Our ref: PSM3427-001R

RE: REVIEW OF HUME COAL PROJECT RESPONSE TO SUBMISSIONS JUNE 2018

**REVIEW OF HUME COAL PROJECT RESPONSE TO SUBMISSIONS JUNE
2018**

PSM3427 26 SEPTEMBER 2018

Figure 1 – Comparison of adopted hydraulic conductivity values

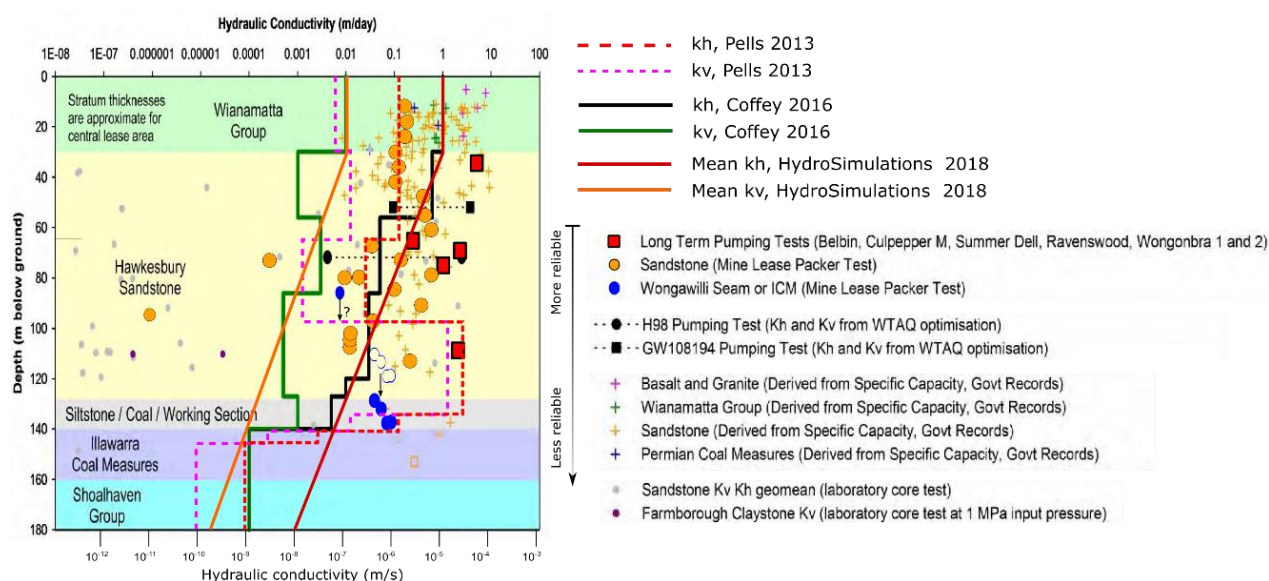
Figure 2.7 of Pells and Pan (2017), which compared adopted hydraulic conductivity values, has been reproduced as Figure 1 below, but now also includes the mean hydraulic conductivity values reported in HydroSimulations (2018, Figure 18). It can be seen in Figure 1 that in this location the function of decreasing hydraulic conductivity with depth used by HydroSimulations (2018) approximates values adopted in the EIS studies previously presented by Hume Coal. Table 22 of HydroSimulations (2018) indicates that the vertical conductivity “Kv” is approximately equal to kh/50, which also approximates vertical conductivity used in the EIS studies previously presented by Hume Coal. The revisions in hydraulic conductivity, relative to the previous EIS studies, are considered by HydroSimulations (2018) to be small enough that “the model remains appropriately calibrated and is fit-for-purpose” (HydroSimulations, 2018 pg. 30). HydroSimulations (2018) have not revised calibration to Berrima colliery but attach the previous EIS model study, relying upon its calibration.

Hence, the criticism that I made previously of the hydraulic conductivity values remain. The criticisms have not been addressed and in some ways, as explained below, the problems have been exacerbated.

Figure 2 – Spatial variation in hydraulic conductivity in the lower Hawkesbury Sandstone (Coffey 2016a, Figure 5.6) – note edits have been made to reduce “logK” values to units of m/day

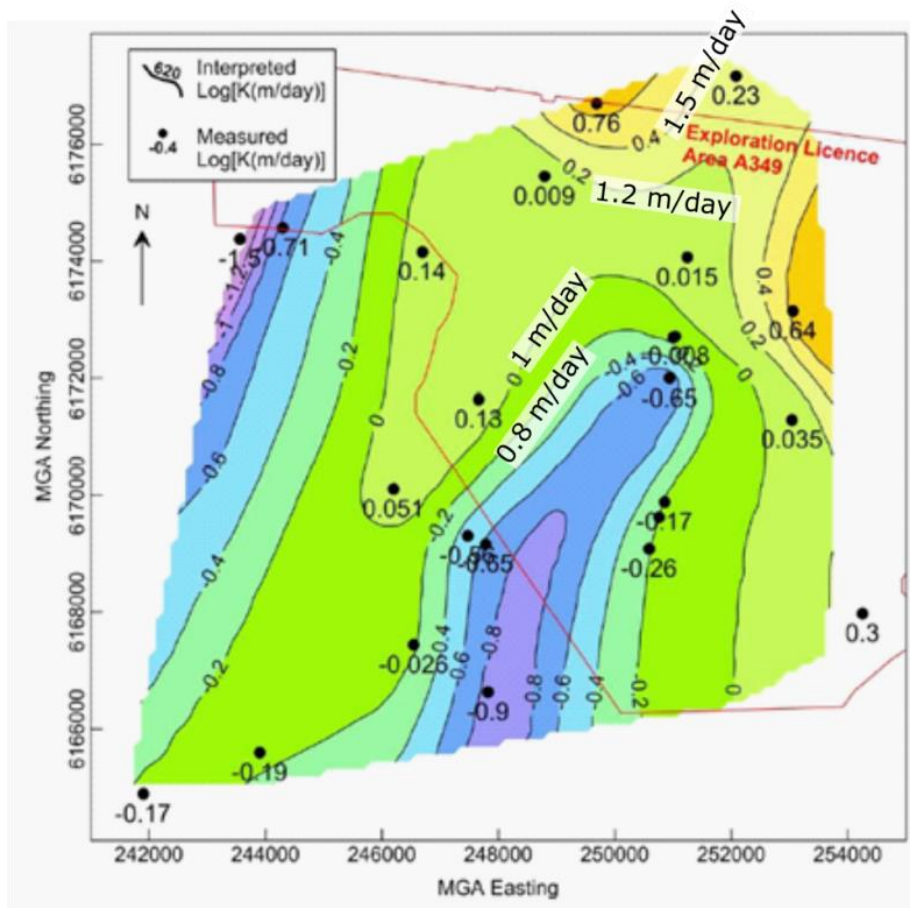
Data analysis in the EIS by Coffey Geoscience 2016a (attached as Appendix E to the HydroSimulations 2018) presented the spatial variation in hydraulic conductivity for the Hawkesbury Sandstone for an interval between 14m to 44m above its base, based on “*the large number of K measurements for the Hume lease*” (pg37). Results presented in Figure 5.6 of Coffey Geoscience (2016a) have been reproduced as Figure 2 below. Over the lease area, measured values of 0.8 to 1.5 m/day agree with the conceptualisation of Lee (2000), and are over 50 times larger than values adopted in modelling for the EIS.

The EMM (2018) report suggests that the higher yields found in various boreholes reported by John Lee are due to these bores intersecting fractures. I agree that this is a possible interpretation of yields, at least for some of the bores, although it does not explain why higher yields are evident at depth² and does not explain the data in Figure 2 from the EIS. Vertical fractures within the Hawkesbury Sandstone are typically ubiquitous in the formation. If the high yields are from fractures they would occur at any depth, not just above the seam.

Nonetheless, if this is the interpretation to these borehole yields put forward by Hume Coal – i.e. fracturing of the formation above the mine - why was this interpretation not adopted within the Hume Coal modelling? Modelling in the EIS assumes no such fracturing or joint swarms. I contend that the presence of such features, as argued in the EIS, would significantly affect simulated inflows and drawdown.

Figure 3 – Layering in the EIS groundwater model

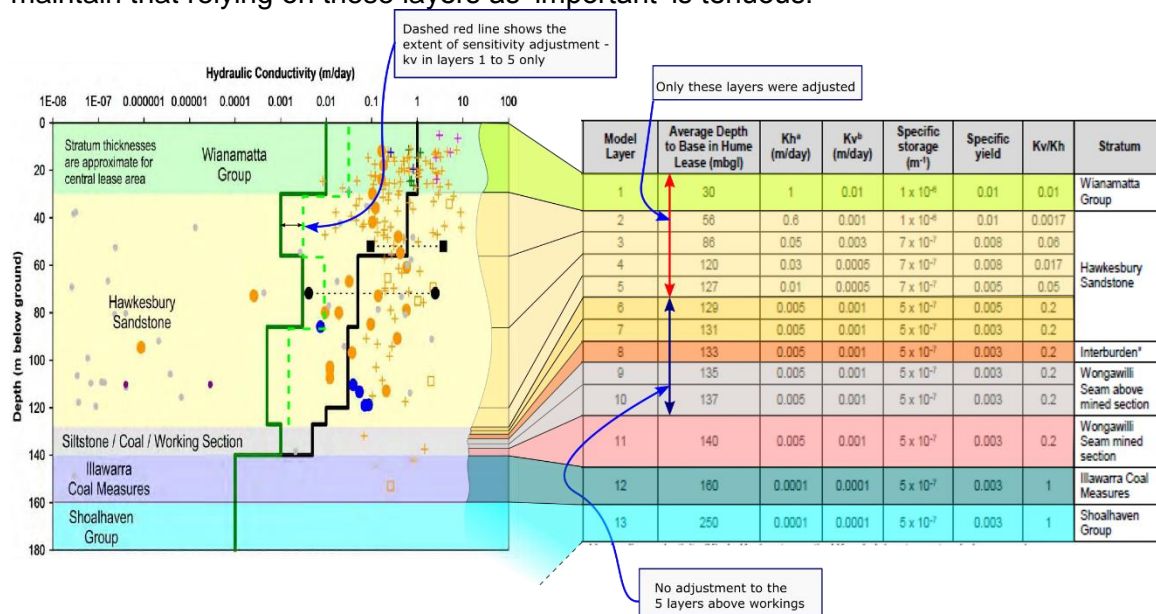
Hydraulic conductivity values adopted in the EIS studies are shown in Figure 3 below, and it can be seen that the EIS model incorporated a number of thinner layers (layers 6 to 8) above the coal measure layers (Layers 9 to 11). These layers all adopt a horizontal hydraulic conductivity of 0.005 m/day (6×10^{-8} m/s) and vertical hydraulic conductivity of 0.001 m/day (1×10^{-8} m/s). Pells and Pan (2017) argued that these values were too low for representation of coal measures, including data presented by Hume Coal (see blue dots in Figure 1 above), and are lower than values for Hawkesbury Sandstone above, constraining flow above the mine, without any test data as justification.

interburden within the model.” (pg. .9). This answer just addresses a lax usage of the term “interburden”, but does not answer either of the fundamental questions, being:

- What data support the lower values of formations (EIS layers 6 to 8) above the coal seam?, and;
- What data support the low values for the coal seam?

The presence of lower conductivity layers above the mine seam, whose parameters were controlled uniquely in modelling for the EIS, indicates interpretation that “*claystone and thin coal plies (Narrabeen Group and uppermost Illawarra Coal Measure rocks above the Wongawilli Coal Seam) has been recognised as important in the EIS model*” (EMM, 2017, pg. 7). Given the erratic occurrence of these formations in bores³, and their likely disturbance from mining (even with the proposed ‘first workings’ methodology), I maintain that relying on these layers as ‘important’ is tenuous.

Figure 5 – Complete calibration to Berrima groundwater levels presented in the EIS

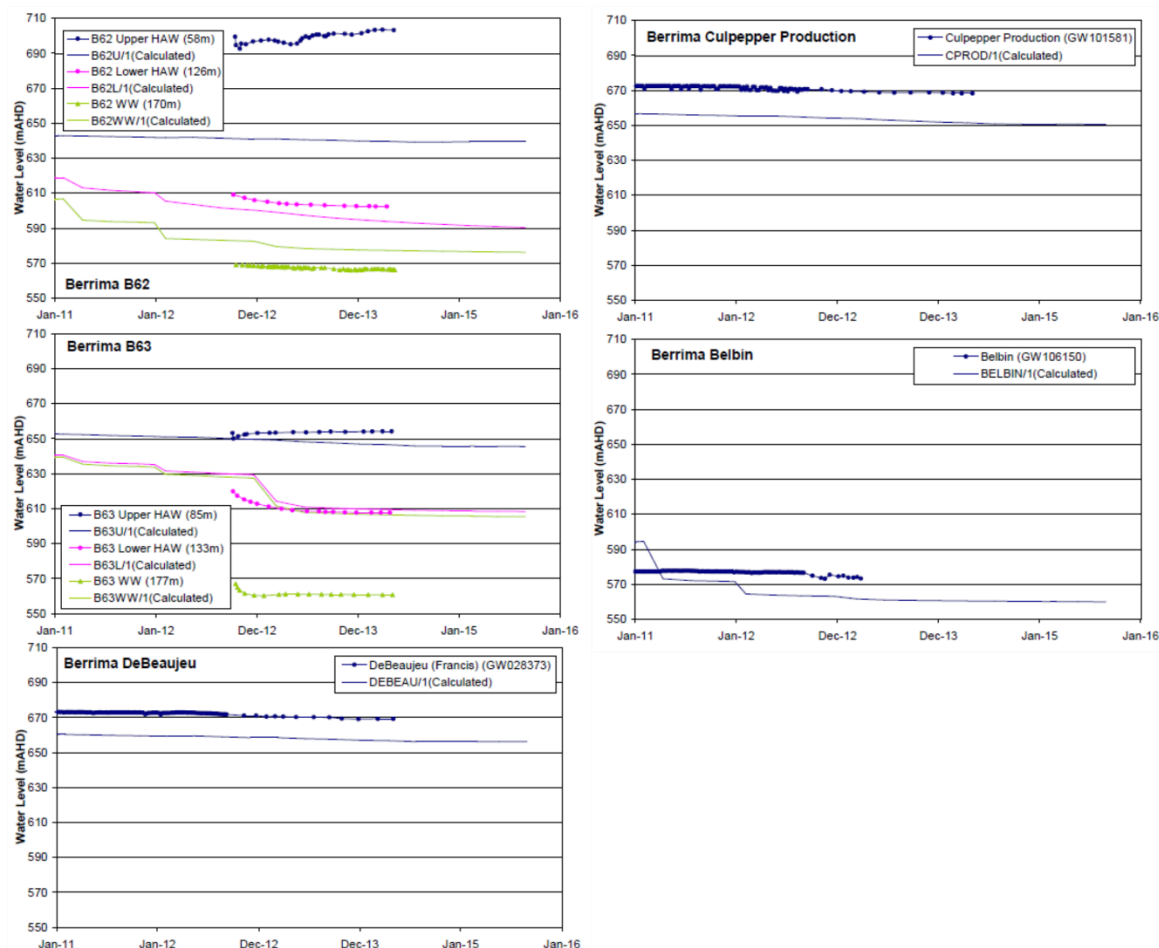
Figure 4.6 of Coffey Geosciences (2015b) demonstrates a reasonable match between simulated inflows to Berrima colliery and outflow monitoring at Berrima. As regards drawdown, Table B1 of Appendix B of Coffey Geosciences (2015b) stipulates that observations from 5 boreholes were used for calibration of groundwater levels at Berrima. The location of these bores are presented in Figure 4. The hydrographs presented for calibration are reproduced in Figure 5 below. The hydrographs extend for periods 1 to 3 years.

No plans or sections showing the groundwater model grid or layout or on the placement of drain boundaries are presented.

Previous groundwater models of Berrima colliery for Boral and Delta Mining showed maps of simulated groundwater levels over the colliery, demonstrating drawdown to seam level. No such plans showing model results over the Berrima colliery are presented in the EIS for Hume Coal. I cannot see from the provided information how groundwater levels over Berrima colliery were simulated. The calibration claimed in the EIS relies upon simulation of the hydrographs shown in Figure 5. It can be seen that groundwater levels are not accurately reproduced by the model in many cases – being up to 50m of discrepancy. Furthermore, it can be seen in Figure 4 that these bores are restricted to the northern perimeter of Berrima colliery. They are inadequate for characterisation of drawdown at Berrima mine.

In summary, the information provided in the EIS does not provide confidence that Berrima colliery has been simulated appropriately.

1. Presentation of plans showing the model grid over Berrima colliery
2. Presentation of where drainage boundaries were placed, both in plan, and demonstrating which layers they were placed in, in section.
3. Presentation of simulated drawdown over the Berrima colliery during the calibration period
